File: Netronics ASCII Keyboard.kicad_sch

Title: Netronics ASCII Keyboard II Replica

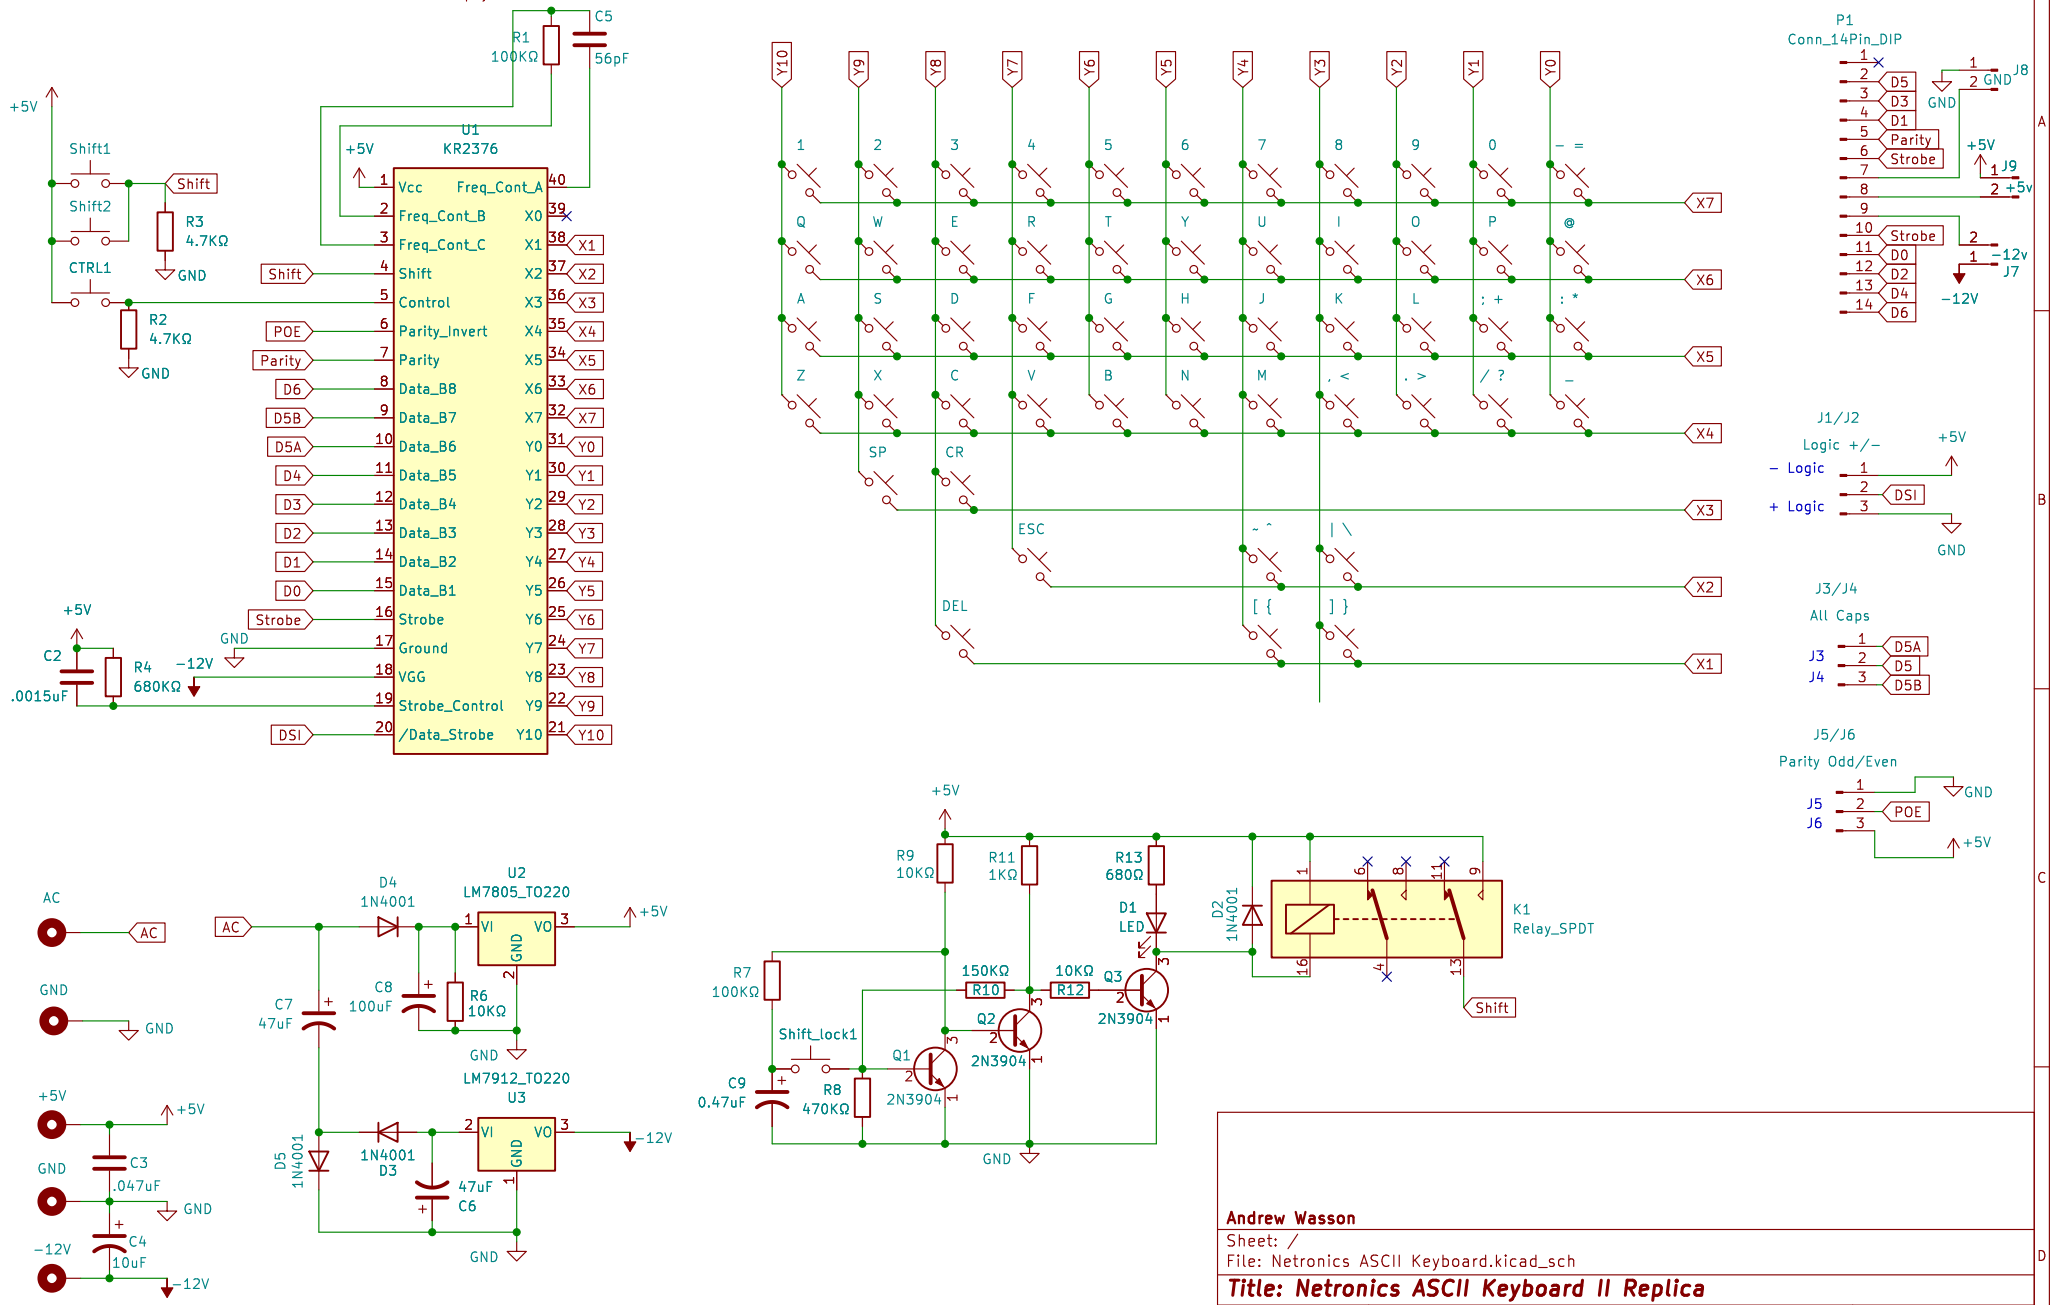
Correction:
Pins 2, 3 are reveresed on the original schematics
but correct on the physical board.
